ABP— 317828-23

**ABP Ref: ABP-317828-23**

**FCC Ref: F23A/0301**

**Observation: US CBP (Customs Border Protection) extension and SASC (South Apron Support Centre)**

**Fig 1** Visual proof of the long overdue controlled passenger flow into the CBP facility which now eliminates the historical panicked rush to clear the US CBP facility.

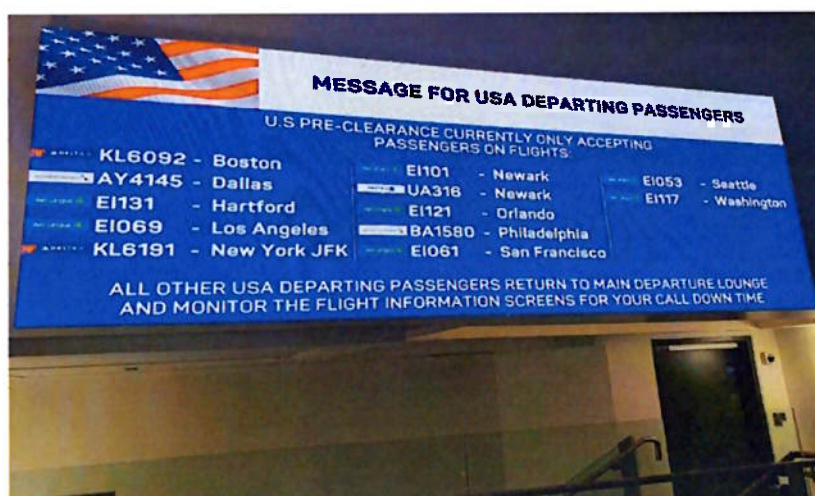
However, now that the April 2023 TSA screening trial has been stress tested in the busy summer 2023 season we can once again compliment the DAA and US CBP officials for adopting the new TSA security processing requirements with enhanced FIS (Flight Information Screens) and main terminal signage (Fig 1 Below).

(Note: In this appeal the DAA and its agent have failed to acknowledge the new TSA screening procedures adopted in April 2023.)

**Figure 3-4 – RIBA 2 Design Layout**

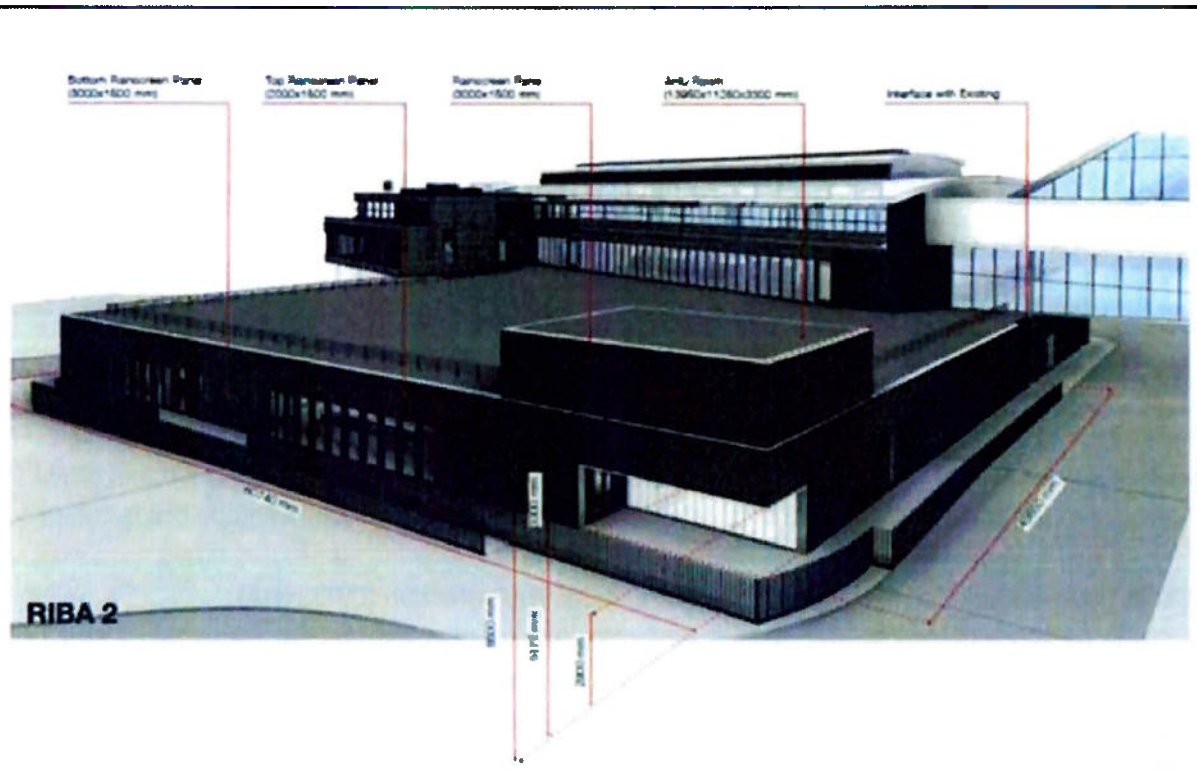
Therefore, it's accurate to state that the current facility does meet the requirements of T2 and DAA requirement to expand this facility to the basic RIBA 2 standard (EIAR main Vol 1 page 41 of 279) at Fig 1 is therefore not "urgently required".

**Fig 1.** The expanded ground floor RIBA 2 design (eliminating existing contact stands) is not required to meet current passenger numbers.

**Fig 2.** 1140am Historical overflow queue lanes (prior to entering the US CBP) are no longer required.

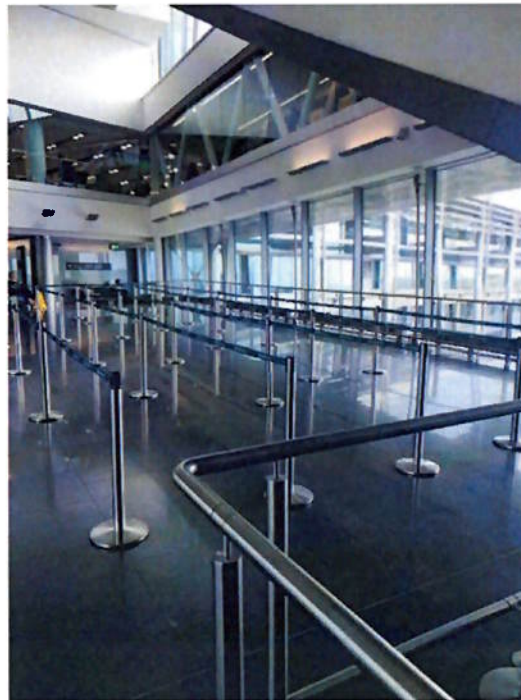
Consequently, the current area allocated to TSA screening prior to CBP can be radically reduced and thus provides adequate opportunity to repurpose the existing ground floor to facilitate additional CBP officer booths thus further improving and reducing the overall CBP processing time.

- That FCC issue a RFI in order to clarify the different US passenger processing and queueing within the TSA and CBP facility in June 2022 compared to June 2023.
- That the FCC planning officer chooses a random day with minimal notice in order to personally view the new TSA / CBP process and validate the improved passenger processing.

Fig 4. The F23A/0301 Final Design, a future proofed US CBP facility encroaching apron space and lacking indicative connection to IAG Pier 5.

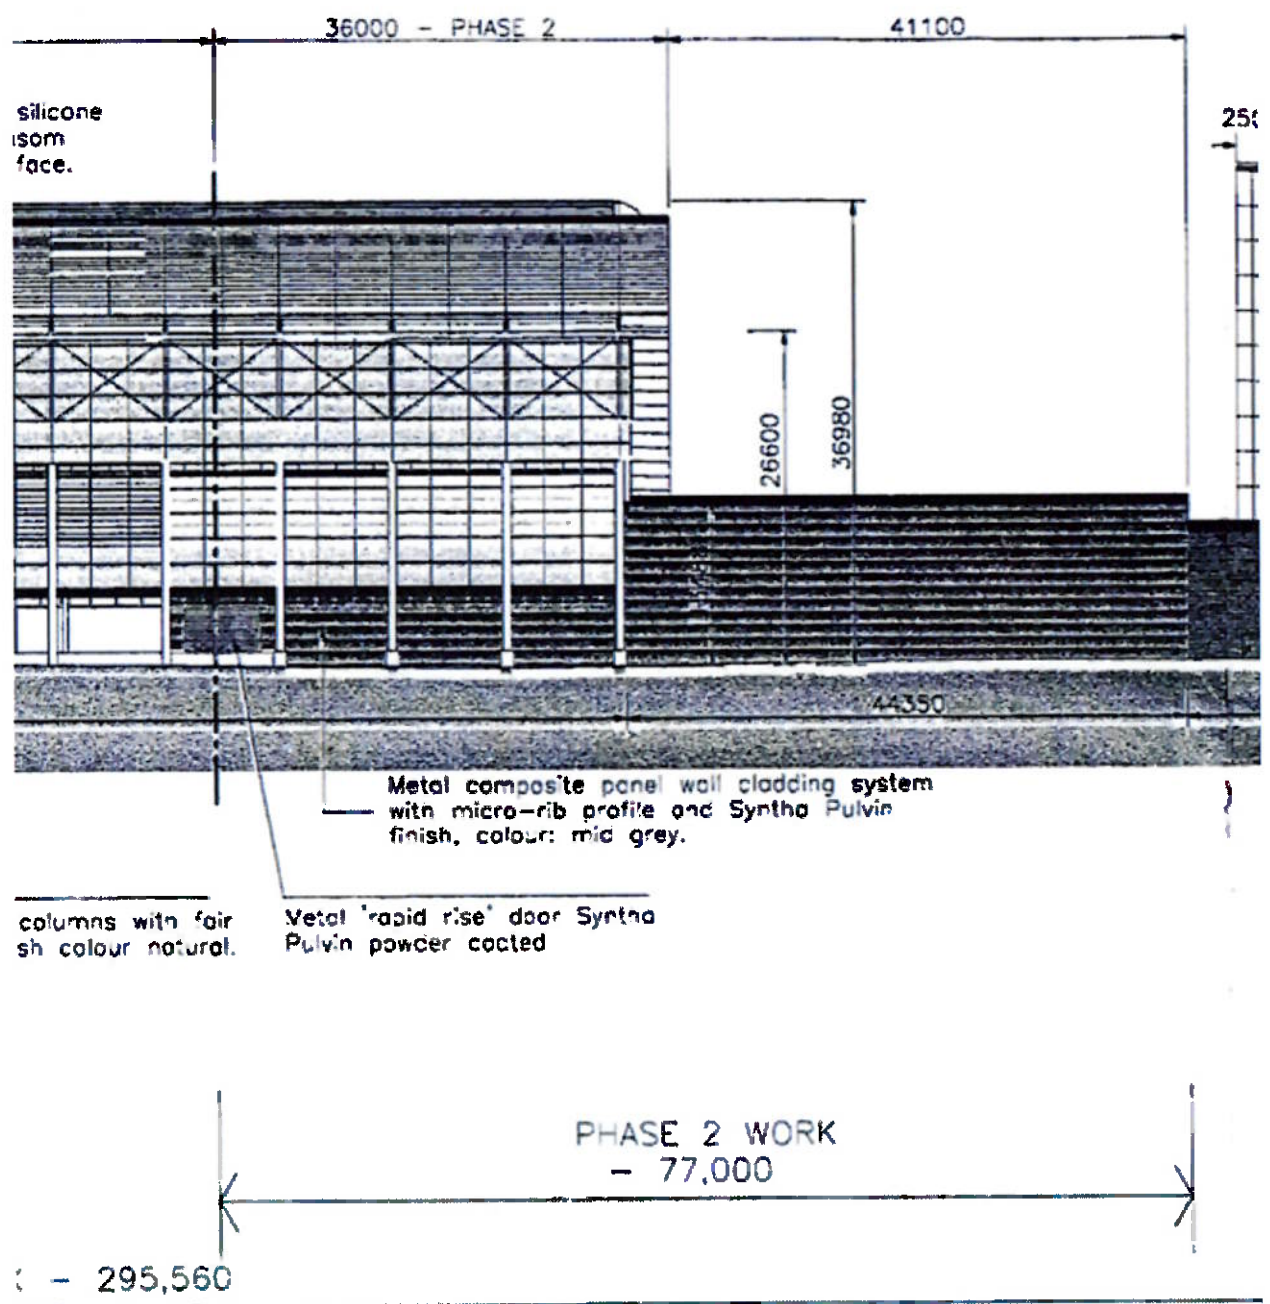
In some respects the proposed expansion of the US CBP facility at F23A/0301 is akin to putting "the cart before the horse" because clarity is required as to where IAG is permitted to locate its Pier 5 within the South apron.

- What contact stands shall be served (within the South Apron) when the future proofing sections of F23A/0301 (with links into T2 departures and immigration) become fully operational?
- Shall IAG's proposed Pier 5 footprint restrict T2 Phase2 development?

**Fig 8.** IAG aspirations for the South Apron with unresolved dubious: stands, taxiways, jet blast issues and a relocated South Gates PBZ close to the 28L-10R flight strip, approach and public safety zone.

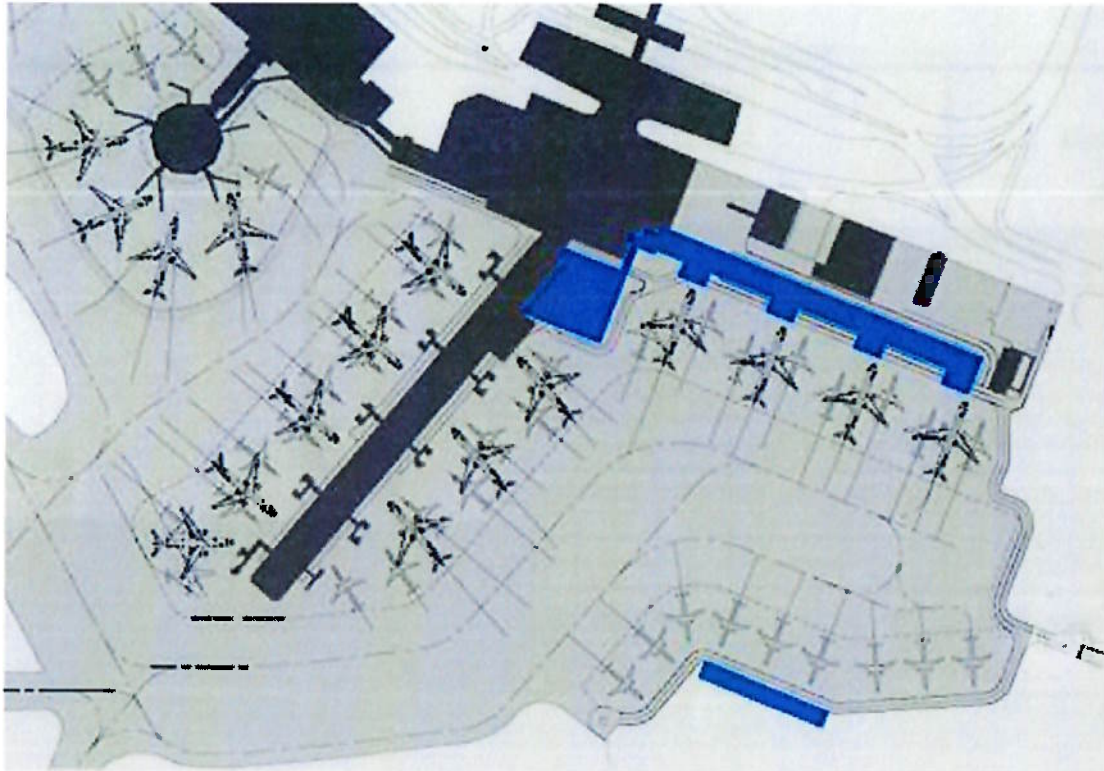
The IAG preference is to develop within the South Apron whilst S&T preference is to progress and banish wide bodied aircraft from the Eastern Campus.

Essentially, guidance (no doubt sought by all in an RFI) shall give clarity and determine if FCC eventually seeks to protect the Terminal 2 Phase 2 expansion site or permit IAG Pier 5 to thwart same.
